Sonoma County Design Review Committee STAFF REPORT

FILE: ADR20-0069
DATE: May 19, 2021
TIME: At or after 1:30
STAFF: Joshua Miranda, Project Planner

REGARDING > **ADR20-0069 Appeal Response**

SITE PLAN
A1.0

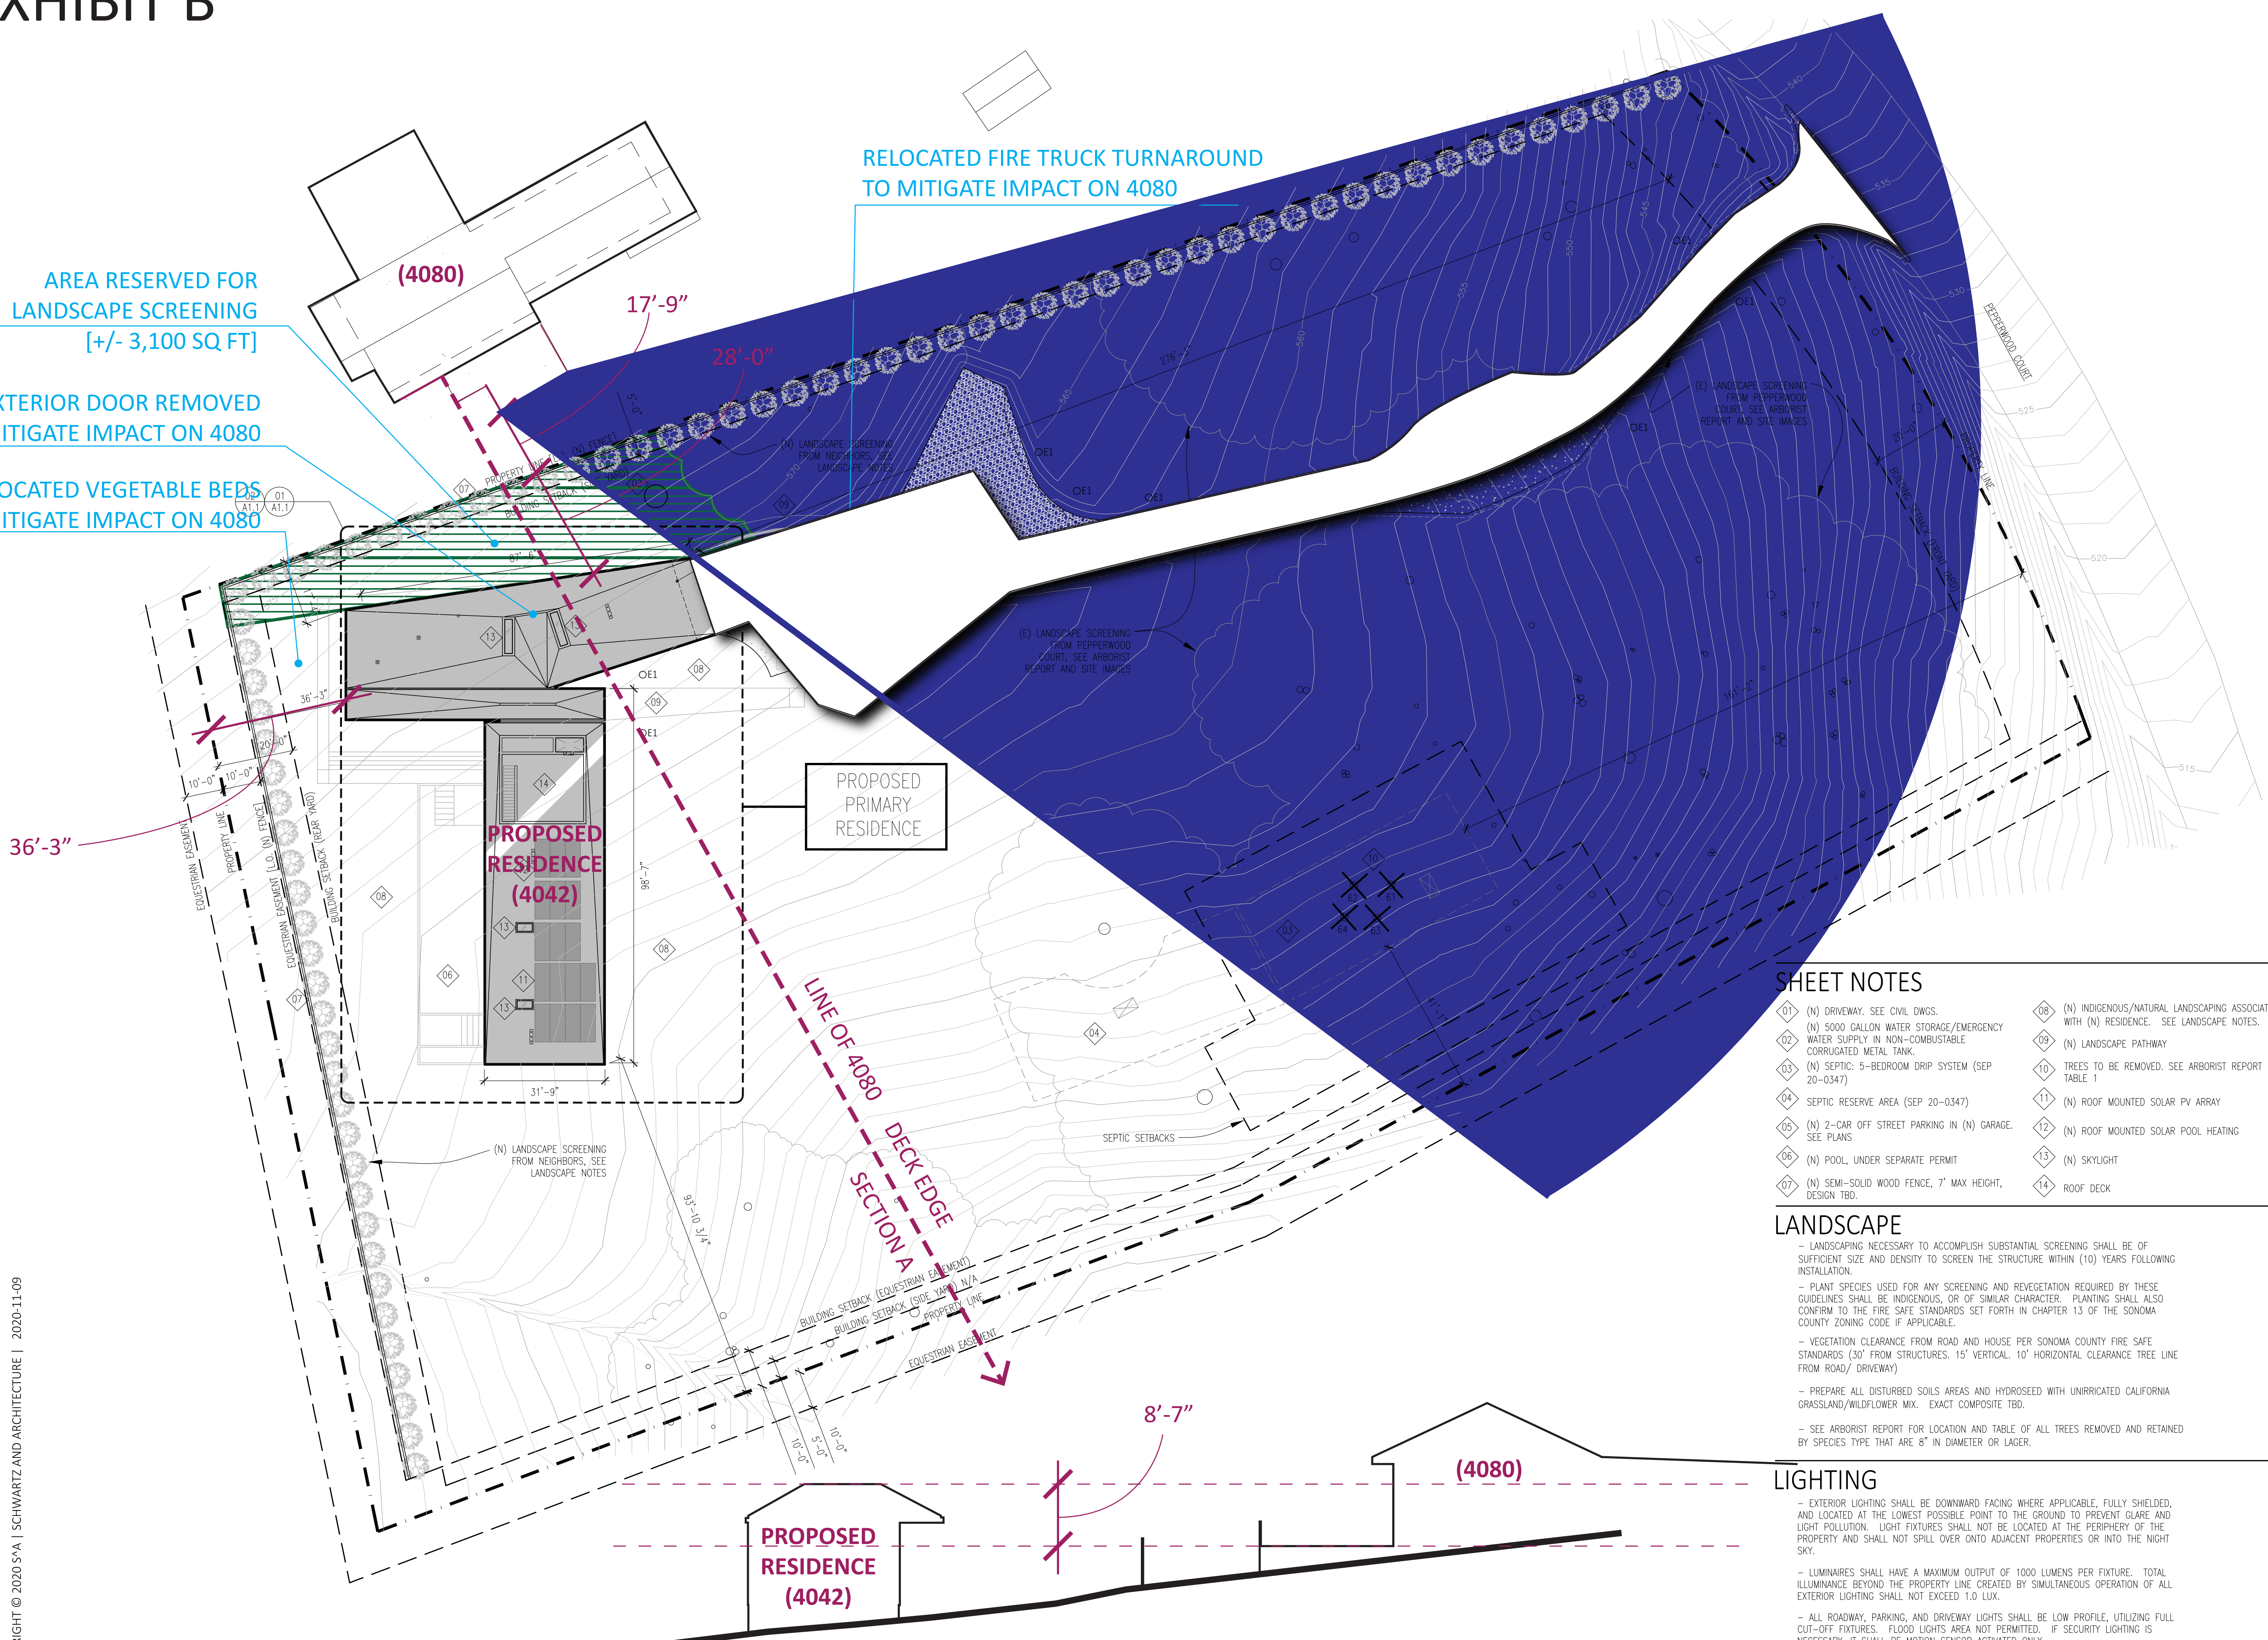
- > The neighbor’s appeal claims that it is the “prevailing norm” in Diamond A that efforts are made to “adequately” separate homes from one another to provide “wiggle room” — **an especially specious argument given the neighbor’s own home is built closer to their property line than our proposed project (Exhibit A).**

- > The height limit for the project is 35' (as determined by Planning code) yet our home is only 24' in height, **a full story below this**. As documented by the Coordinator of the Diamond A ARC, the original intention was for a two-story home in the same location, but we opted for a one-story home over a garage as a more site sensitive approach, particularly for the numerous uphill neighbors looking down on the property.

- > Given the proximity of the uphill neighbor's home and multiple accessory structures, our home is sited to allow for significant and dense landscape planting between the two properties. In addition, it has now been developed to have no doors and minimal windows on the side facing the uphill neighbors. Because of the presence of their home looking down and across our property, the buildable area between our homes is not being developed for any outdoor social spaces, program, or activities.

- > We propose to relocate our planned vegetable beds (and thus the activity around them) to the area west of our home along the property line with **dense landscape screening**, to the extent viable given fire safety standards.

- > Associated with the vegetable bed removal and because of this appeal process, we have decided to **remove the one door from that side** of our home facing the neighbors, so there will now be no access along that façade.

EXTERIOR DOOR REMOVED
 TO MITIGATE IMPACT ON 4080

RELOCATED VEGETABLE BEDS
 TO MITIGATE IMPACT ON 4080

RELOCATED FIRE TRUCK TURNAROUND
 TO MITIGATE IMPACT ON 4080
